MEMORANDUM

Project: Summer Moon Coffee
699 NW Blue Pkwy, Lee's Summit, MO 64086

Re: Commercial Final Development Plan, Application No. PL2023042

The following are responses to address the FDP comments received on 3/15/2023.

WDGE1 LED

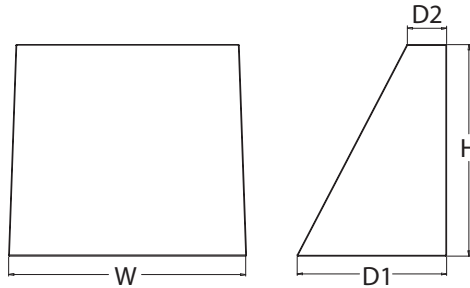
2. WALL PACK LIGHT FIXTURE. Provide a cut sheet of the proposed new wall pack fixture to the left of the new drive-through window for review. Wall packs shall comply with the requirements under UDO Section 8.260.

Response: A cut sheet is provided for the new wall pack light fixture. The EOR confirmed this fixture meets the requirements of this section.
